**ZONING MAP CHANGE
STAFF REPORT**

City Council Meeting Date:
November 10, 2015

Site Location: 11785 & 11815 Alta Vista Road Mapsco: 22F

Request: From: "A-10" One-Family

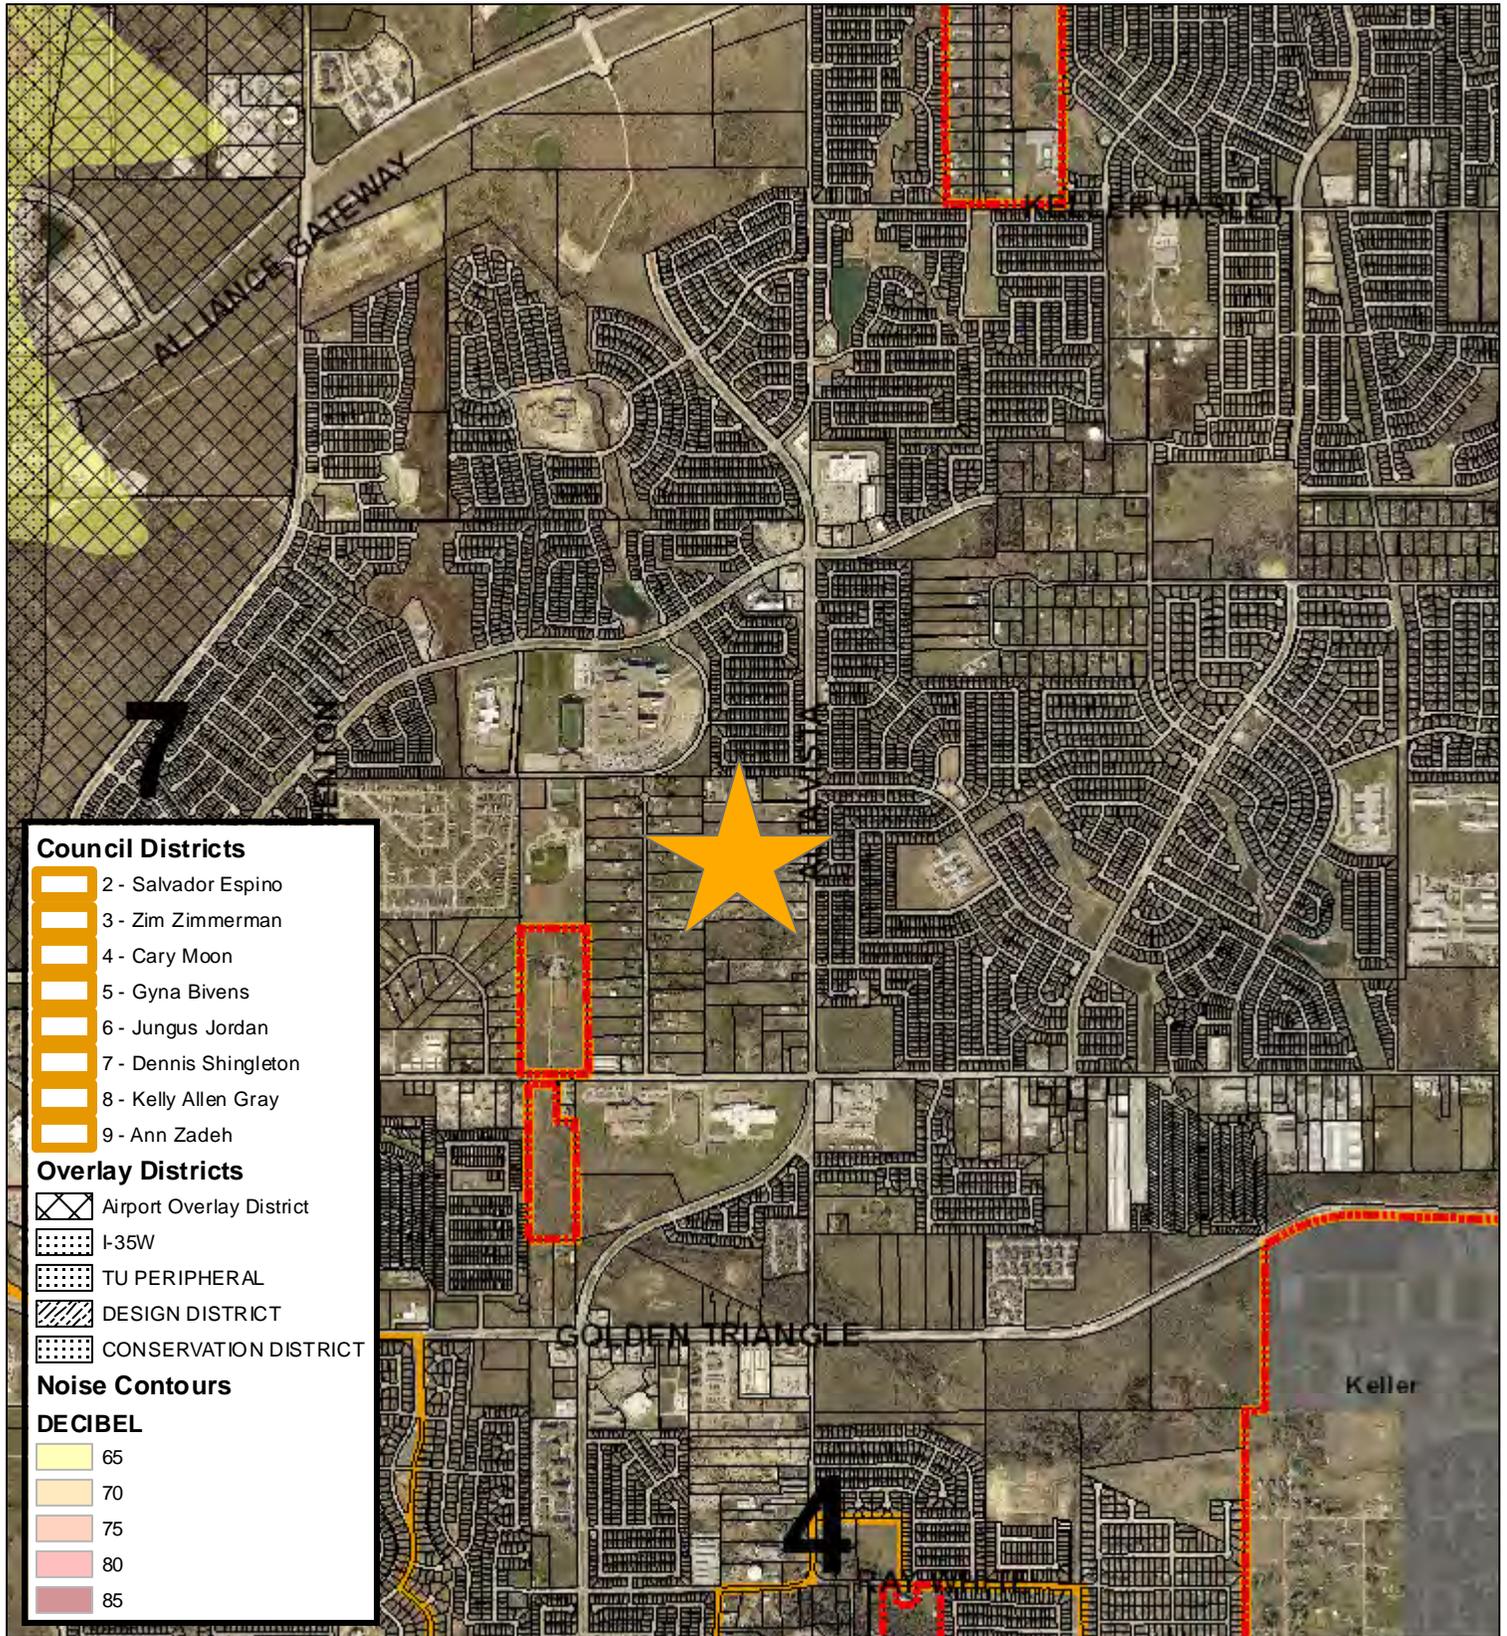
The site plan as submitted is not in general compliance with the zoning regulations. The key deficiencies are:

- 1. 40 percent lot coverage allowed within A-10 (waiver requested, applicant intends to provide 50 percent)**
- 2. 25 ft. front yard setback (waiver requested, applicant intends to provide 20 ft.)**

3. **10 ft. rear yard setback (waiver requested, applicant intends to provide 5 ft.)**
4. **1000 sf accessory building exceed maximums (waiver requested)**
5. **Accessory buildings prohibited within the front yard (waiver requested)**
6. Provide the location of accessory buildings in front yard
7. Structures and accessory building prohibited within easements

1. Need to revise the site plan to indicate the lot widths on the lots. The minimum width for the lots is 65 feet wide at the building line. According to the scale on the site plan these lots are at the most 62 feet wide.

2. Update the lot typical to indicate the location of the structures including the accessory buildings.

3. Remove the secondary entrance it is not necessary since this development has less than 30 units. This secondary access is less than 600 feet from the primary entrance. Per the Subdivision Ordinance local streets intersecting with an arterial must be a minimum of 600 feet apart.

5. The purpose statement is unclear. Please define what is meant by "Accessory Buildings to 1000 Square Feet and Allowed in Front". In front of what? This is why it would be helpful to reflect this on the lot typical

1. Street Centerline Offsets - Street centerlines offset(s) as shown are unacceptable. Centerline offsets shall be at least 600' between local street (s) or collector street(s) and arterial streets. Greater centerline offsets may be required by the City Traffic Engineer. This will require a waiver to be reviewed and approved by the City Plan Commission. Without the waiver approval, the site plan will require major modifications.

2. Cul-de-sac Length - Streets ending permanently in a cul-de-sac shall not exceed 800' for developments with lot sizes less than one acre. For developments with lot sizes of one acre or more, cul-de-sac length shall not exceed 1000'. This will require a waiver to be reviewed and approved by the City Plan Commission. Without the waiver approval, the site plan will require major modifications.

Zoning Commission recommended waivers to items 1 through 5 noted above.
